STRUCTURAL ADDENDUM-No: SA-01

Re: 321 John Street, Cobourg, ON
Clarifications & Updates to Structural Documents

The following items are changes to project Contract Structural Documents. General Contractors shall include the items described in their tender bid including all labour, material, equipment and services required to complete the work described.

S412

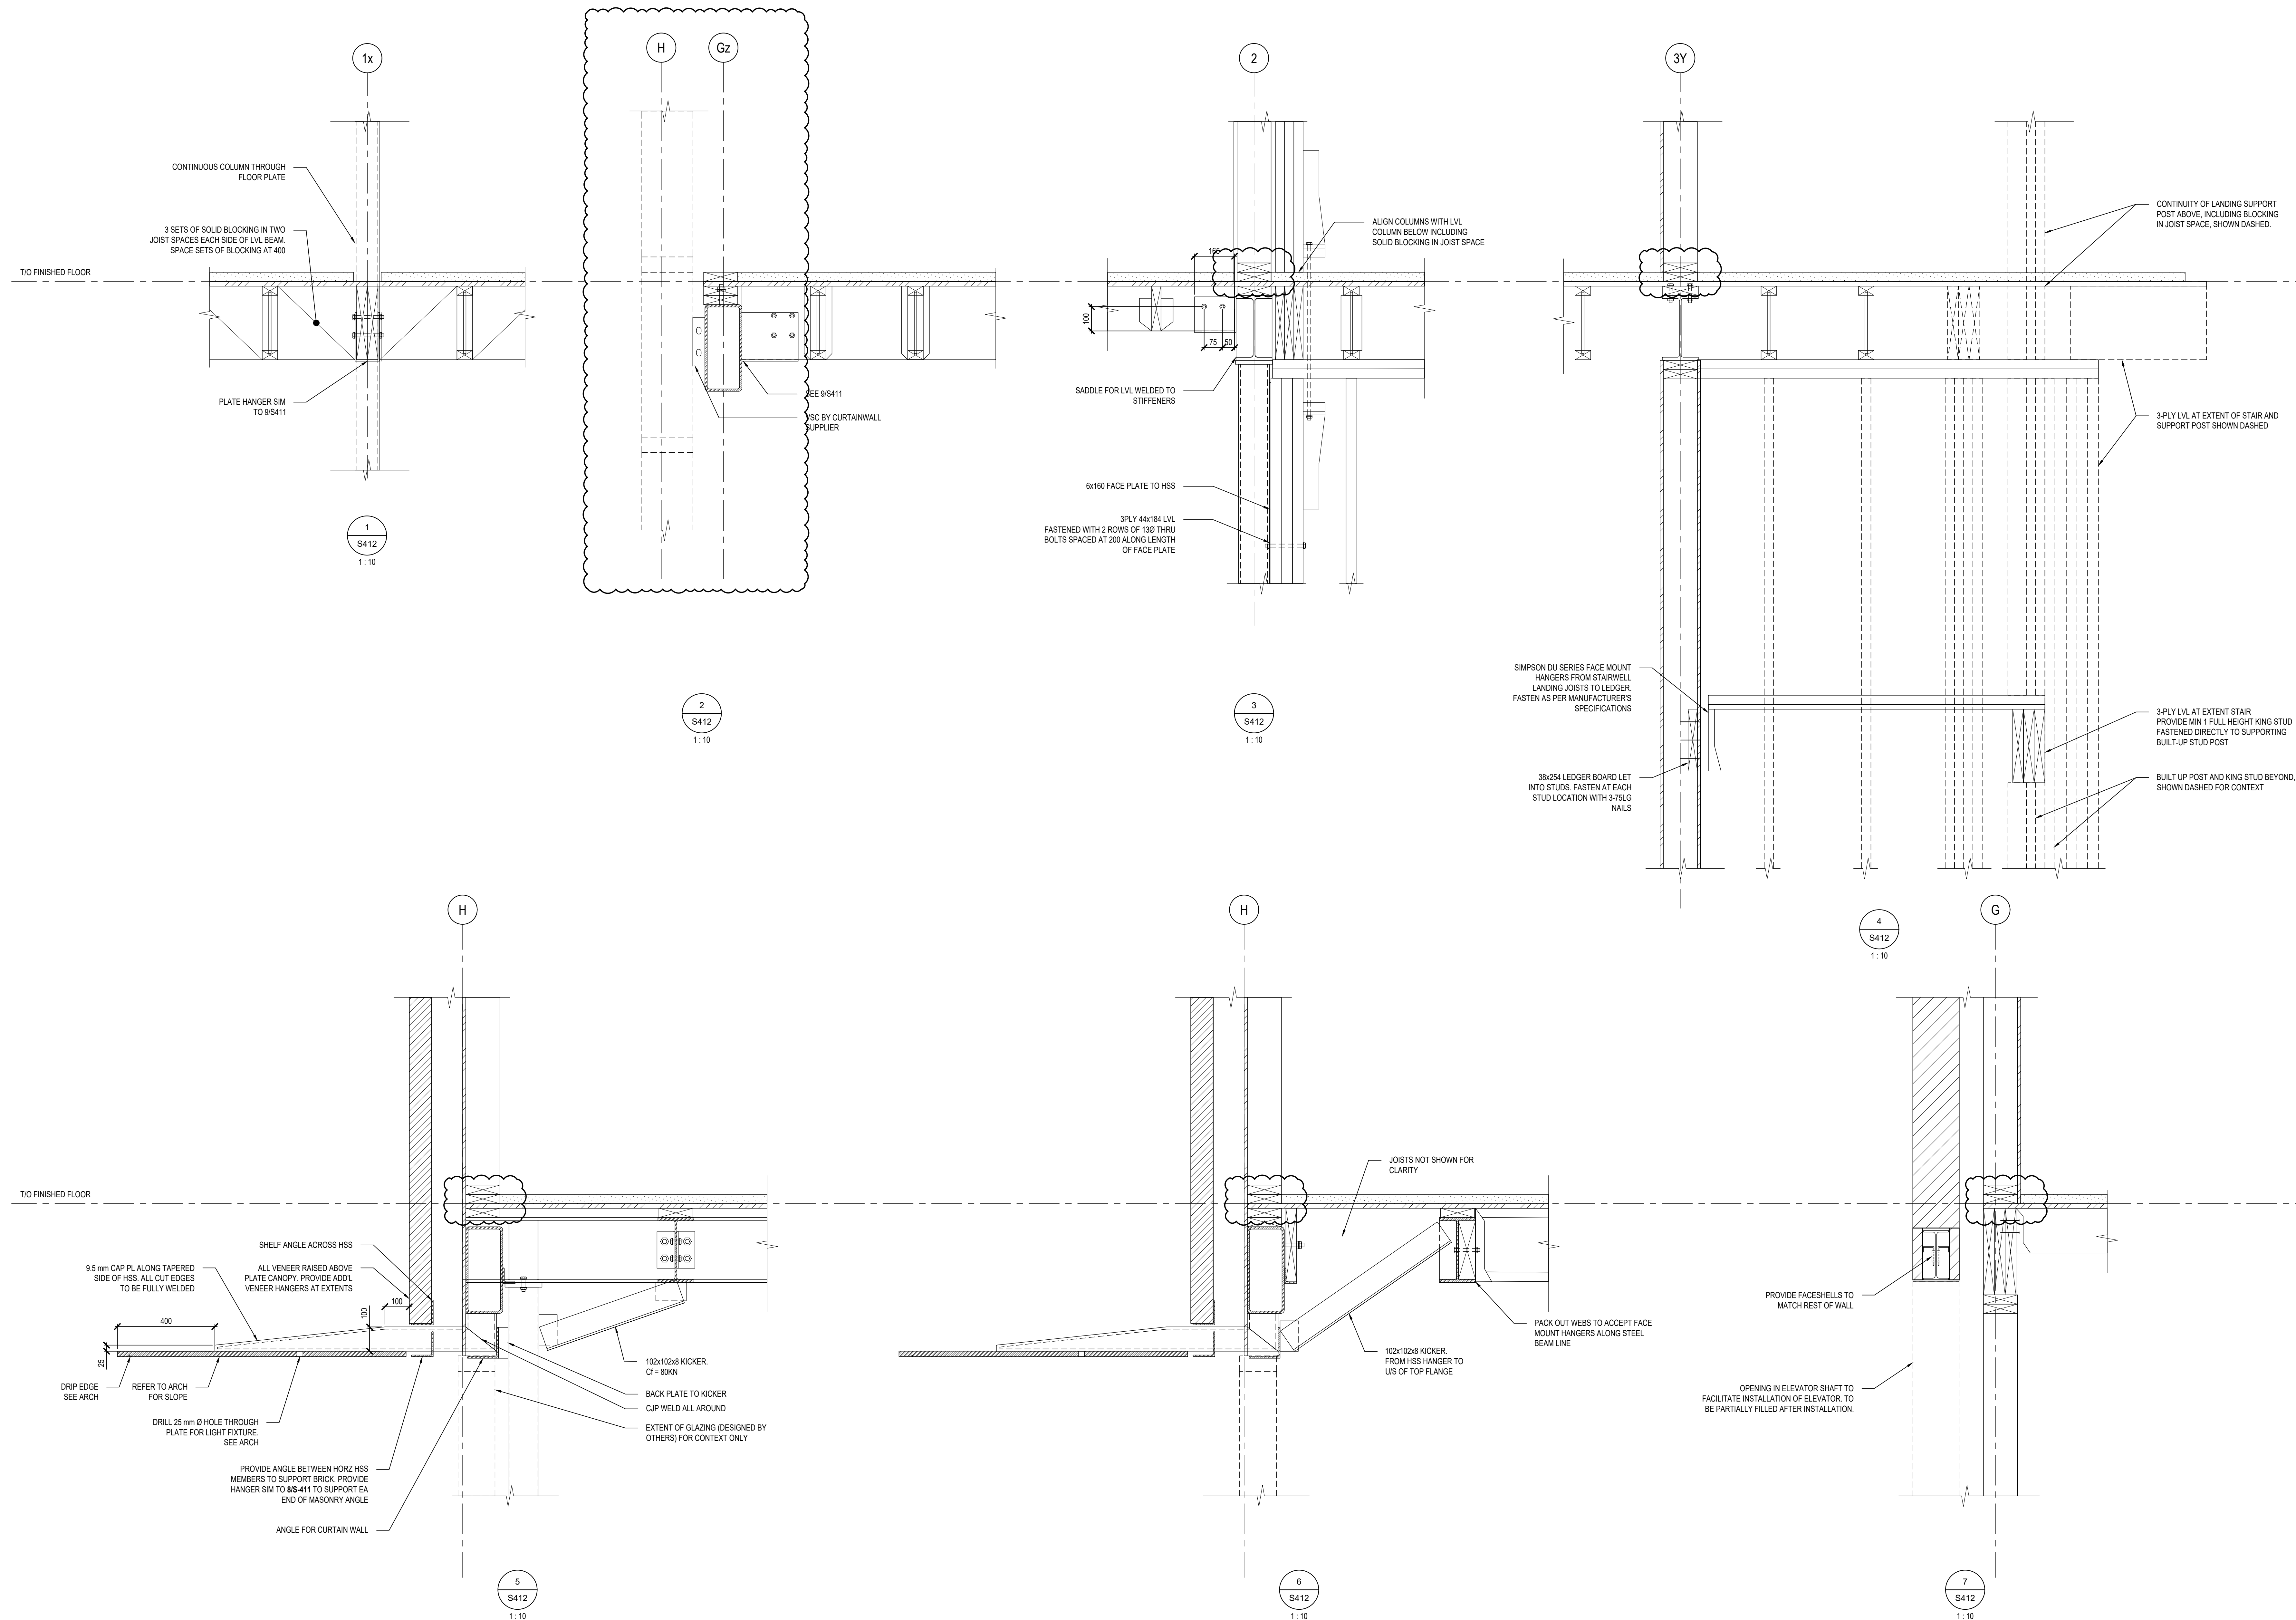
9.0 S412 Sections and Details

9.1 Sections adjusted to show double bottom plate.

S413

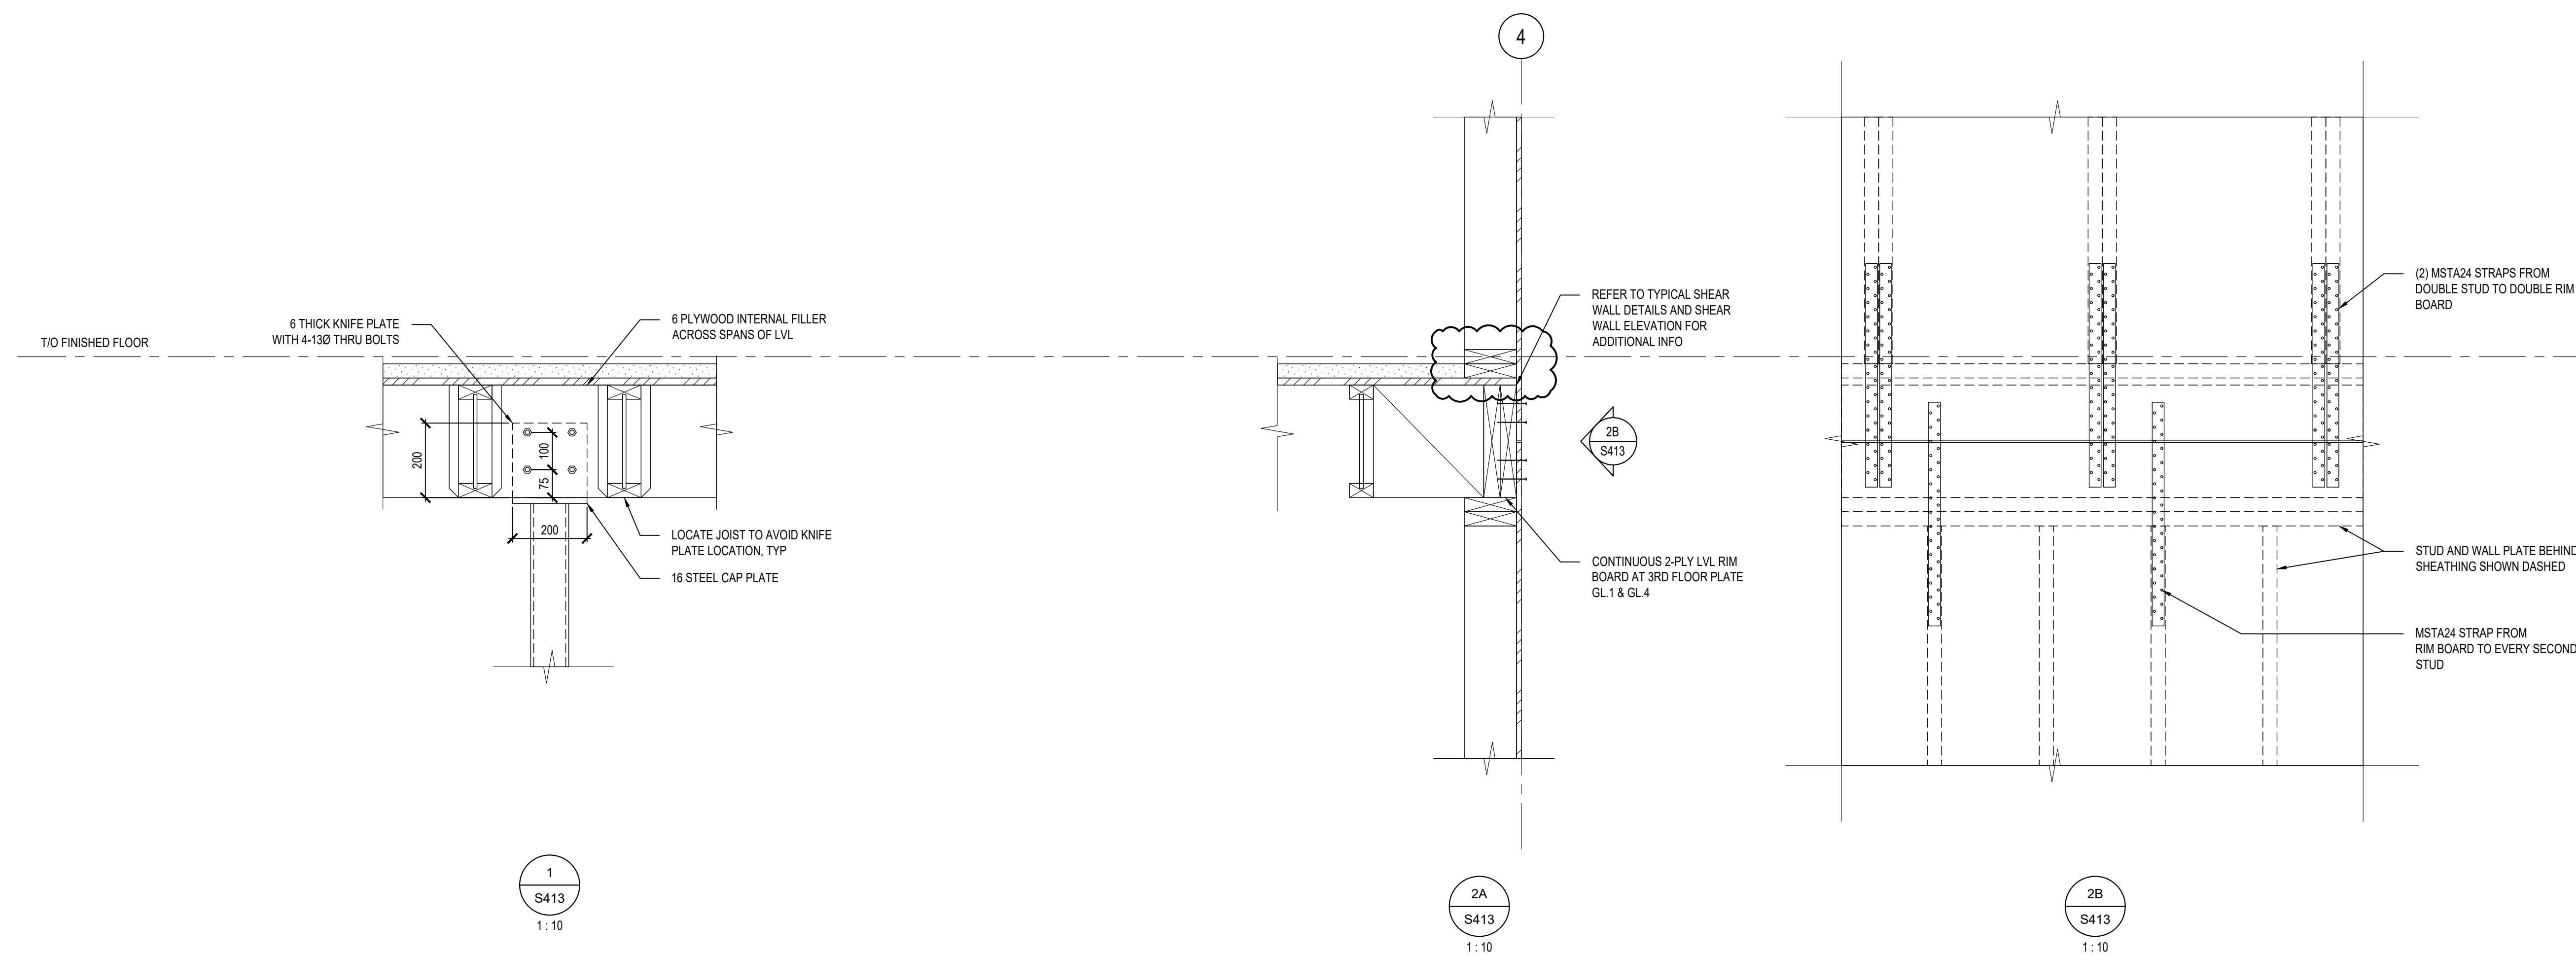
10.0 S413 Sections and Details

10.1 Section adjusted to show double bottom plate.

S414

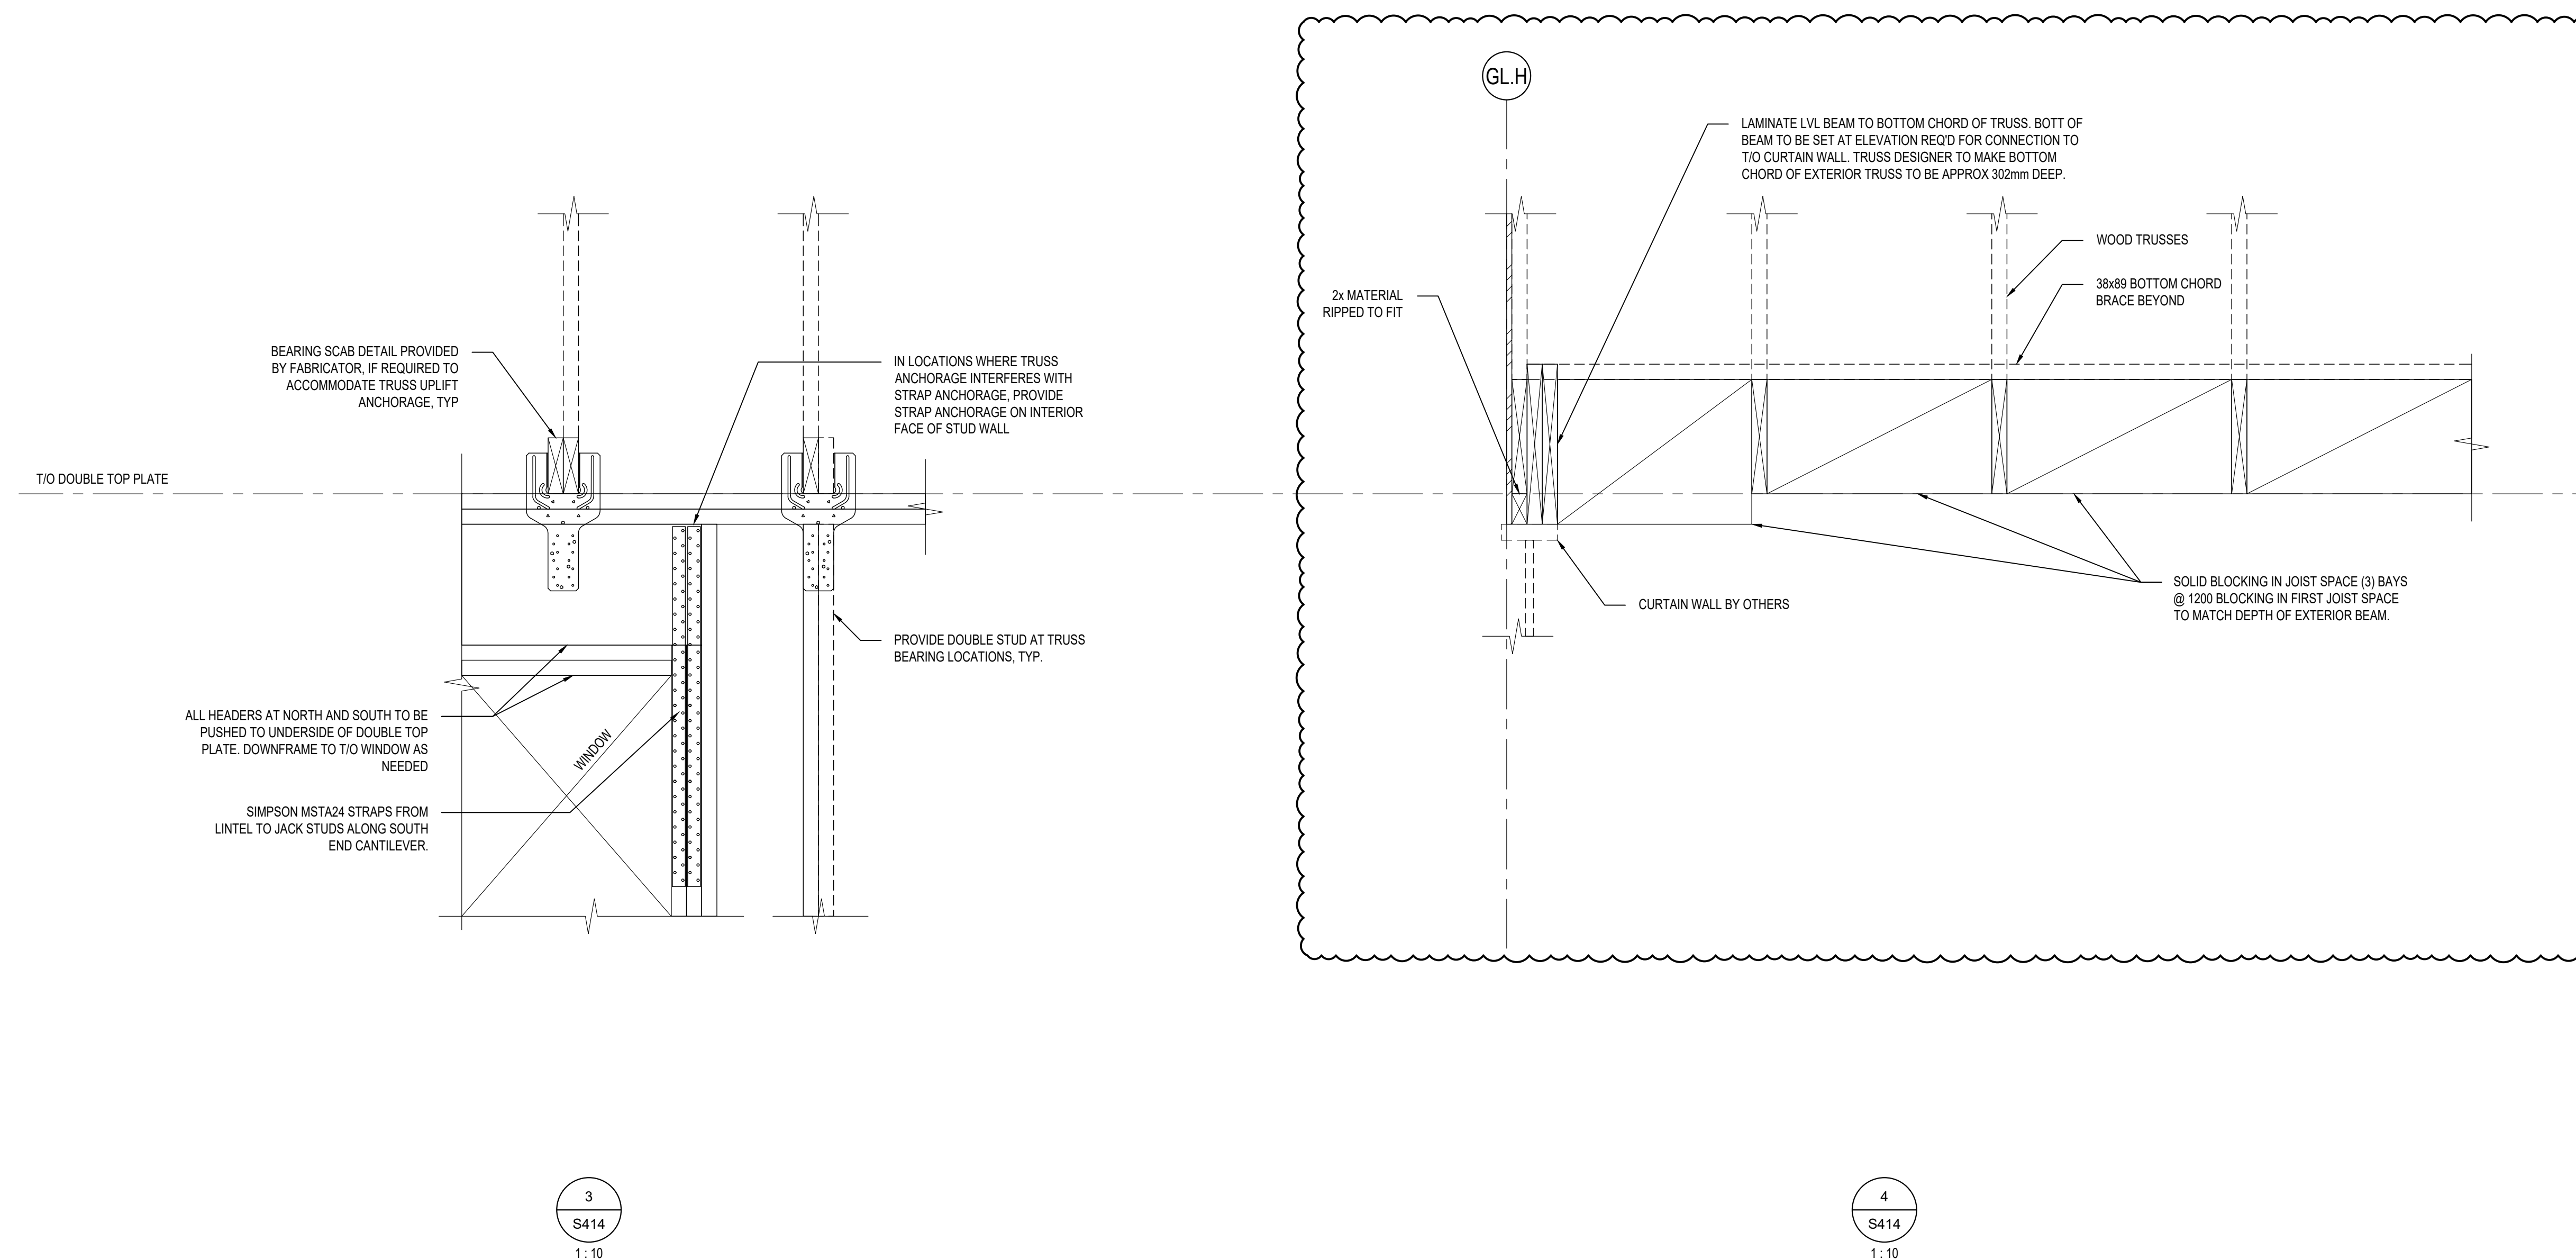
11.0 S414 Sections and Details

11.1 Nailing added to shear wall extension on 2/S414.

11.2 Lintel pushed up to truss space to avoid interference with curtain wall in 4/S414. Brace detailing removed.
